Supporters: Only PD affects PD POWERUP Tinrush max.

IEEE802.3bt

Sep 2015

Yair Darshan

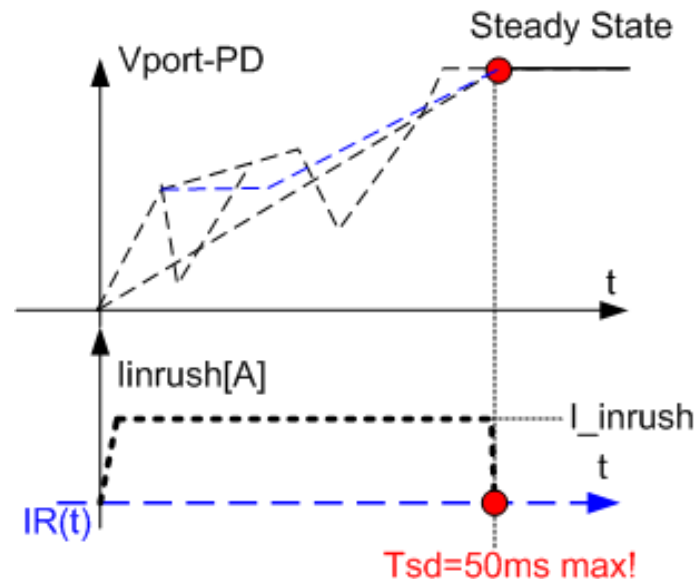
Inrush current per pairset is drawn beginning with the application of input voltage at the pairset compliant with V_{port_PD-2P} requirements as defined in Table 33–18,

and ending before $T_{Inrush-2P}$ min per Table 33–11.

The ending point is incorrect:

The ending point should depend on PD physics (getting to steady state by charging to 99% of C_{port}) and not on PSE inrush timer!

We do need to specify T_{Inrush_min} as maximum time duration for Inrush process in separate row and not as the process end point!

After $T_{Inrush-2P}$ min, the PD shall meet P_{Class_PD} as specified in Table 33–18.

This part guarantees that PD meets Pclass only after T_{Inrush_min} .

This part guarantees that PD will consume power for >Type 2 after T_{delay} .

This part already address the concerns.

Proposed Remedy

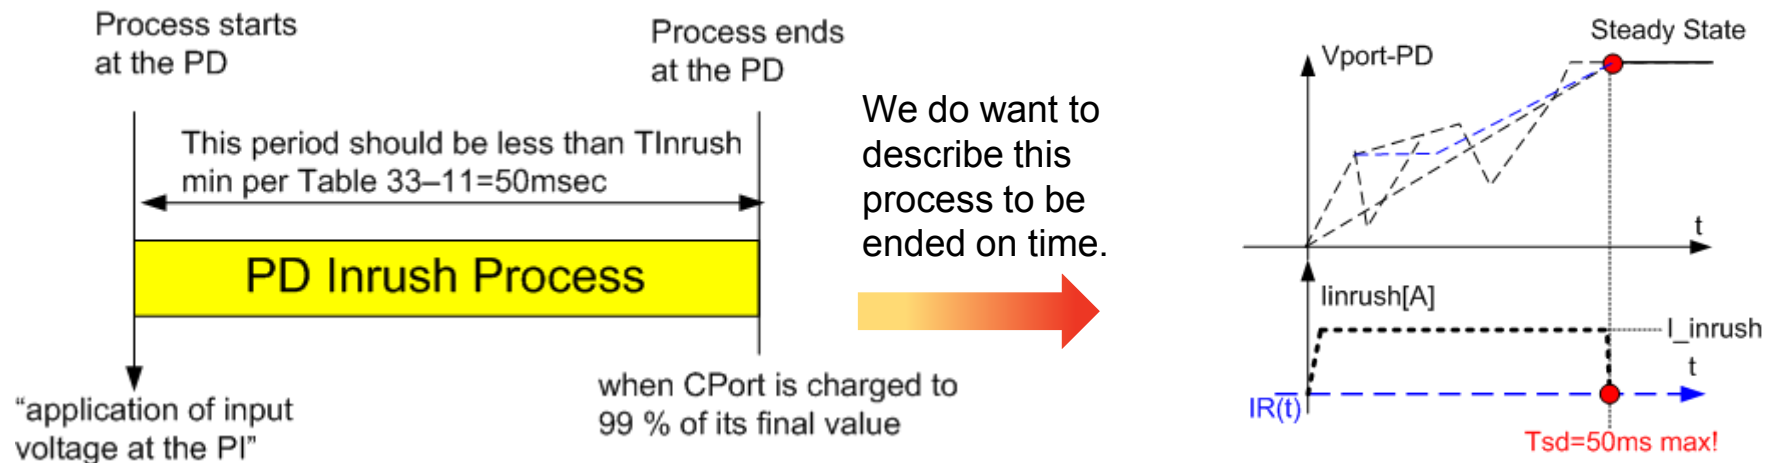
Inrush current per pairset is drawn beginning with the application of input voltage at the pairset compliant with Vport_PD-2P requirements as defined in Table 33–18, and ending when CPort has reached a steady state and is charged to 99 % of its final value.

This period should be ended before TInrush-2P min per Table 33–11.

To consider to add the following note that do address any concerns and supply guide lines.

Note: For successful startup, a PSE supplying linrush-2P minimum value and a PD not drawing more than Type 1 maximum DC current results in stable voltage ramping across the PD input capacitor which is important for successful POWER UP. In addition, Cport value and PD load current may be time dependent. As a result PD implementers need to ensure that for any combinations of Cport and Type 1 maximum DC current during POWERUP, the PD inrush period is not exceed 50msec and higher PD load power should be used only after Tdelay.

Annex B: PD Cport possible variations during POWERUP time duration

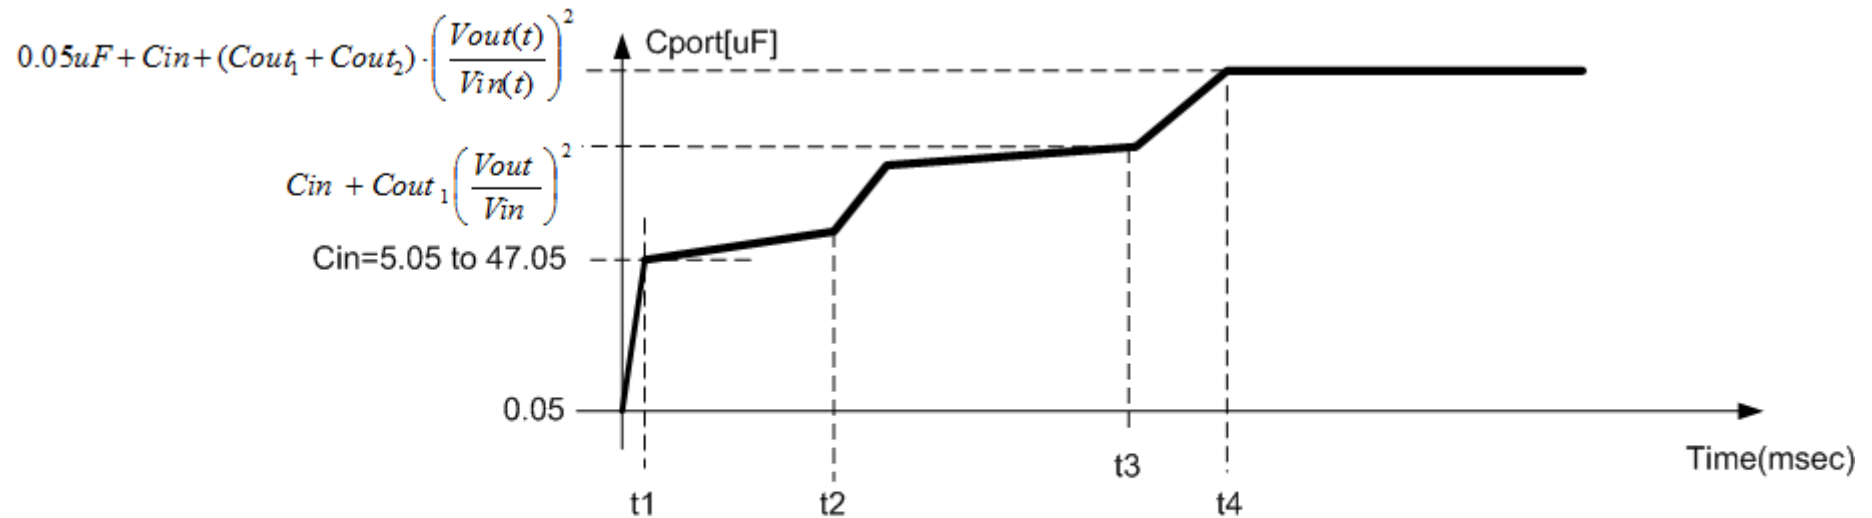
Behavioral qualitative description of PD input capacitance over time.

1. t1,t2,t3 and t4 are implementation specifics.
2. Slopes of capacitance change is function of DC/DC transfer function and soft start.

- Regardless of actual Cport profile (implementation specifics), PD must get to steady state ($V_{port-PD} \frac{dv}{dt} \rightarrow \varepsilon$, practical $\varepsilon \cong 0.01$) within 50msec.
- Only PD physics affect the completion of PD Inrush.
- PSE Tinrush timer has no effect on the completion of PD inrush time.

Annex C: compliant PD test setup for testing PSE POWERUP Inrush and Tinrush requirements

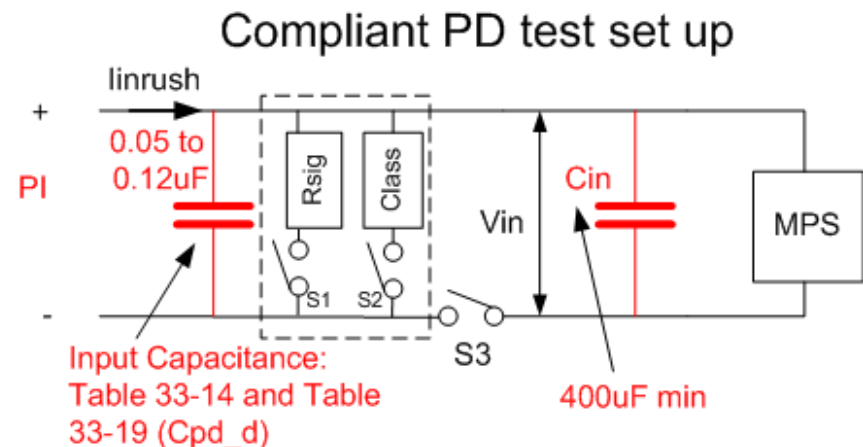
- PSE has to supply startup energy for the worst case conditions.
- The PD test setup will contain big capacitor at its input so Inrush can be monitored for at least 50msec.
- Worst case STARTUP energy is given by:

- $0.5 \cdot V_{pse_max} \cdot I_{inrush_max} \cdot T_{inrush_min} = 0.5 \cdot C \cdot V_{pse_max}^2$.
Resulting with $I_{inrush_max} \cdot T_{inrush_min} = C \cdot V_{pse_max}$

- C_{in_min} in the test setup is:
 $I_{inrush_max} \cdot T_{inrush_min} / V_{pse_max} = 0.45 \cdot 0.05 / 57 = 394 \mu F$.

- Use 400uF min and measure I_{port} that is within I_{inrush_min}/max range for at least 50ms.
